**METROPOLITAN DEVELOPMENT COMMISSION
REGIONAL CENTER HEARING EXAMINER**

STAFF REPORTS FOR DECEMBER 12, 2013

Case Number	2013-REG-123
Address (approx.)	450 East Washington Street (451 East Market Street)
Location	Center Township, Councilmanic District # 15
Petitioner	Maura J. Hoff
Zoning	CBD-2 (RC)
Request	Regional Center Approval to provide for the construction of a mixed-use development, including multi-family residential and commercial uses in two buildings, each of which would be five stories in height. This project is Phase Two of the Artistry Development Project.

Case Number	2013-REG-124
Address (approx.)	2301 North Meridian Street and 2304 North Pennsylvania Street
Location	Center Township, Councilmanic District # 15
Petitioner	David Gibson
Zoning	C-4 (RC); C-3C (RC) pending
Request	Regional Center Approval to provide for a two-story commercial retail and residential development.

Site plan for 2301 North Meridian Street (proposed building) – 2013-REG-124

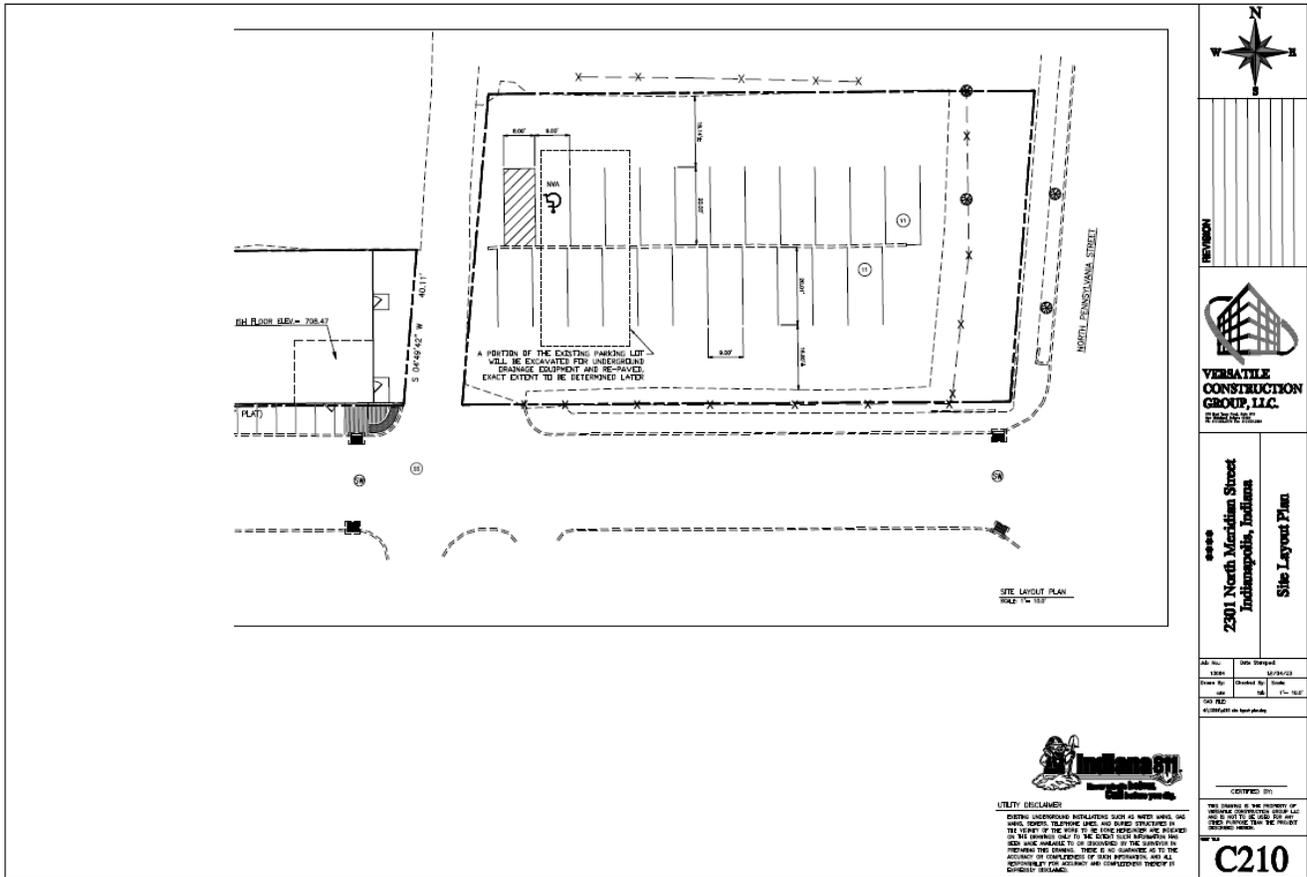
3. Guideline CA 4.4.3 requires a planting area of a minimum four feet in depth when a surface parking lot is adjacent to a public right-of-way or pedestrian way. The surface parking lot at 2304 North Pennsylvania Street would be adjacent to 23rd Street. The revised plan does not indicate any proposed landscaping along 23rd Street. Staff would potentially accept an alternative to the required landscape strip, such as a knee-wall along 23rd Street. An amended landscape plan, or alternate plan, shall be submitted and subject to planning staff review and approval, prior to issuance of an Improvement Location Permit.
